# AIA® Document G701™ – 2017

## Change Order

**PROJECT:** *(Name and address)*  
Clearview Wellness Facility  
4700 Broadway Avenue  
Lorain, Ohio 44052

**CHANGE ORDER INFORMATION:**  
Change Order Number: 016  
Date: December 9, 2022

2018/09/12  
 E-102

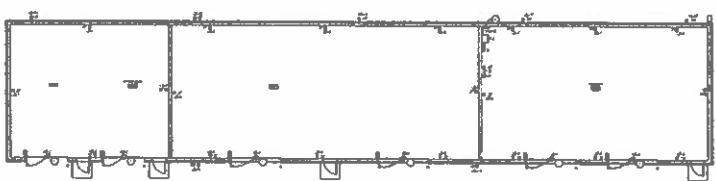
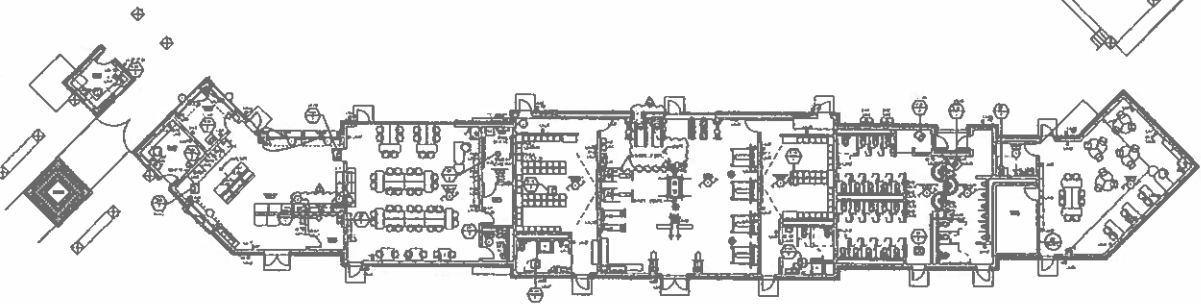
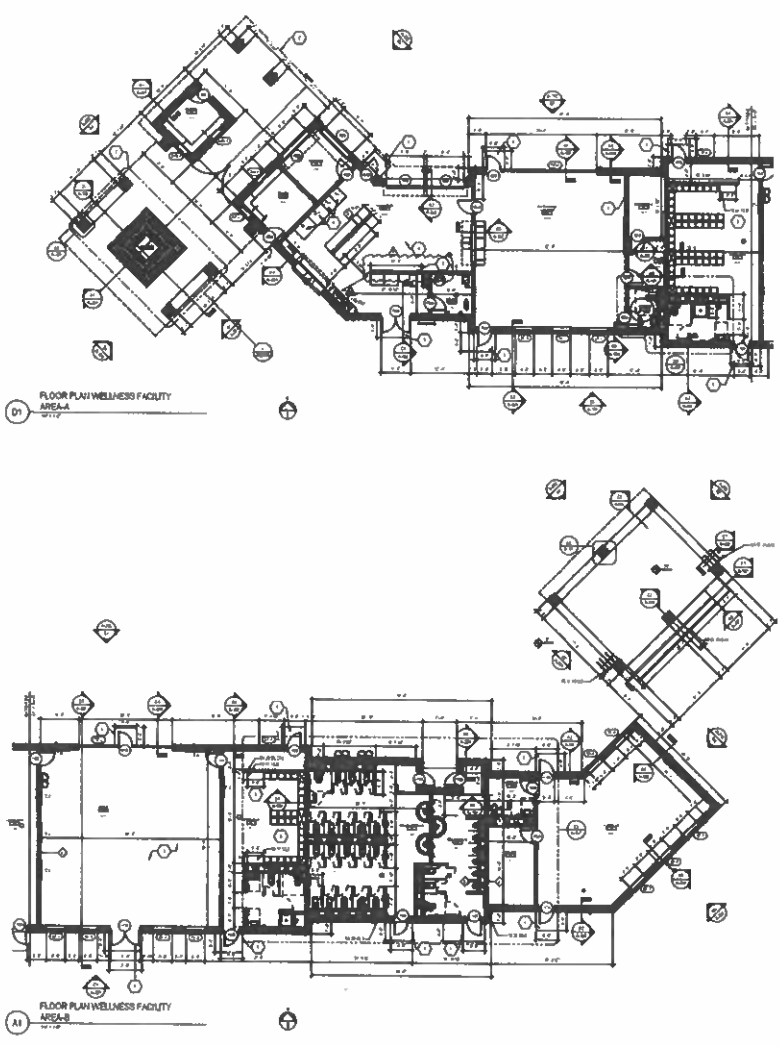
See attached drawings to add exterior lighting to the entry canopy, add power in the concessions area, add outlets for weight room equipment, and add casework and CMU wall for concessions storage.

Scope: provide lighting at canopy, power for concession area, add floor box power for weight room equipment

**A-101**

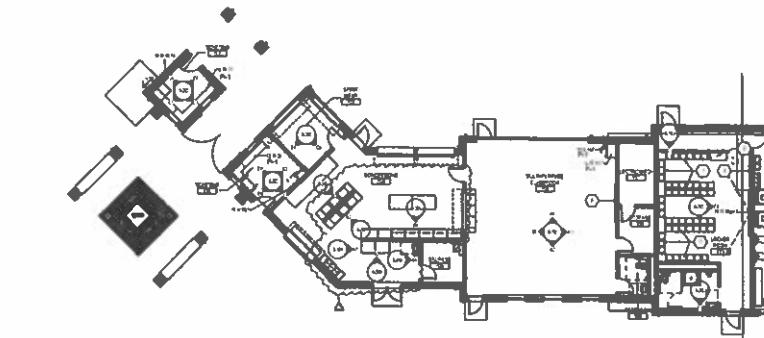
Pricing to add wall to existing double bullnose end stub wall. Including material, labor, equipment, clean-up. Working indoors in tight space, assuming the following: heat/electricity/water readily available, access to the area, and existing protected prior to work commencing.

New 11-0" interior wall with double bullnose at end:

2018.07.19  
**I-502**

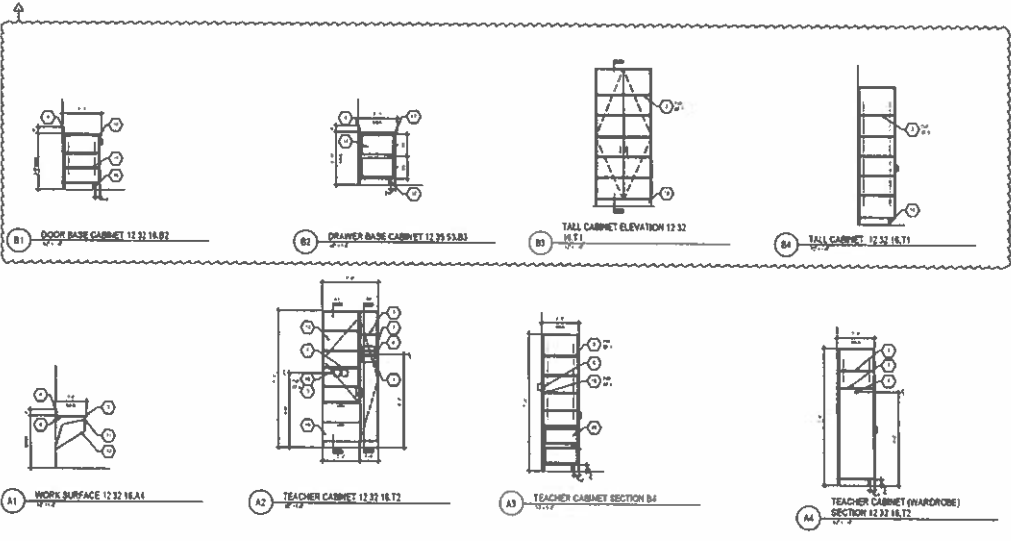
Quantity	Description	Unit Price	Amount
	*****CHANGE ORDER #2*****		
1.00	~ CONCESSION 104 --PLAM WALL AND BASE CABINETS; PANTRY UNITS; PENCIL DRAWERS; PLAM COUNTER TOP	9,295.00	9,295.00
1.00	TRAVEL --ONE WAY TRIP CHARGE	230.00	230.00
	~ **TAX EXEMPT

**PS #5 Rev1 Added 6ft Fence South of BB Field**

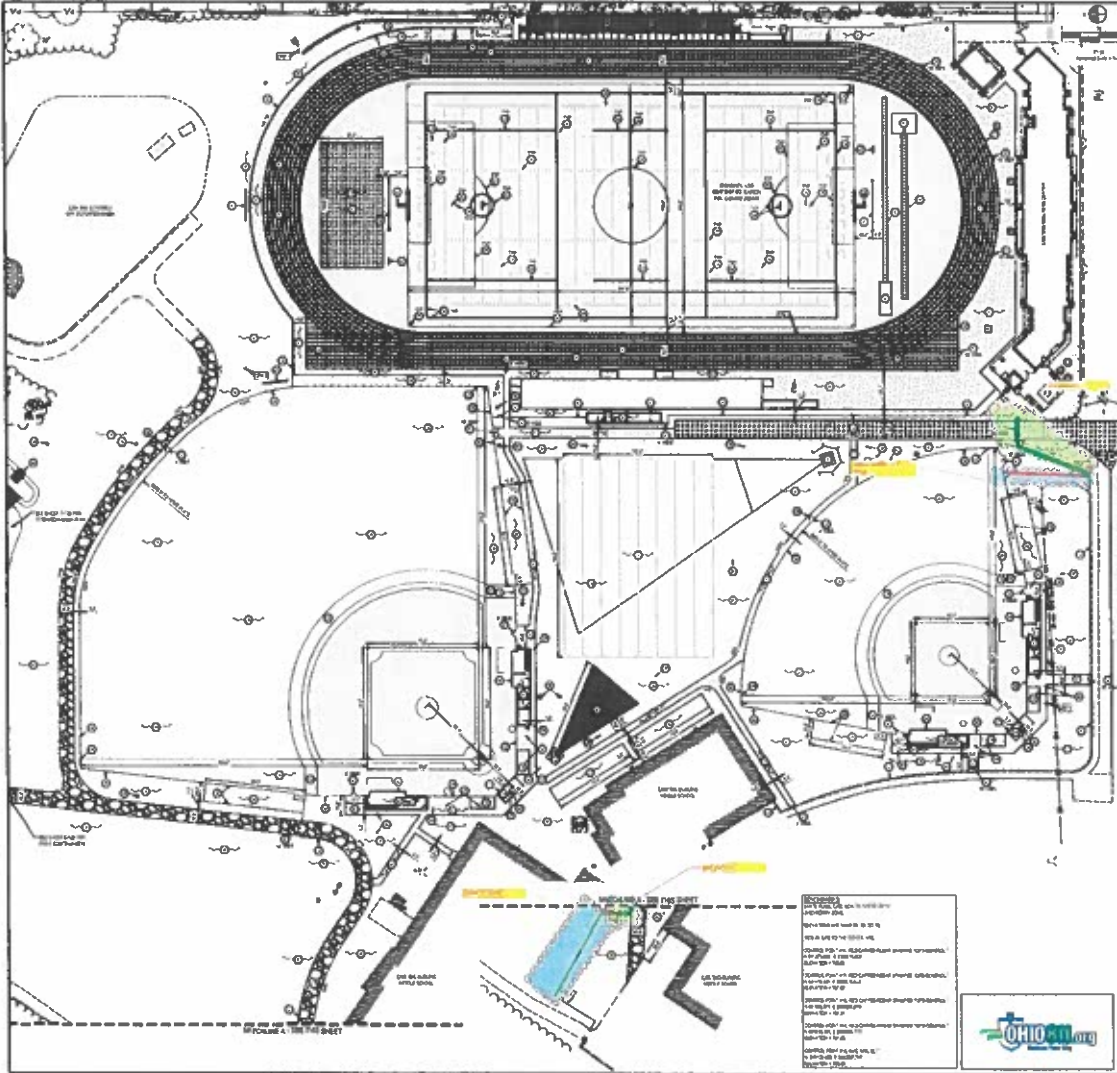
**6ft Black Fence South of Baseball Field (per attached)**

Item	Qty			Units	Material		Labor		Total
	Original	Revised	Adj.		Unit \$	Extended \$	Unit \$	Extended \$	
6ft Black Fence (bid unit price)	28.5	77.2	48.7	LF	\$ 42.84	\$ 2,087.59	\$ 42.84	\$ 2,087.59	\$ 4,176.00
Completed during base bid work									
4ft change was a no cost change
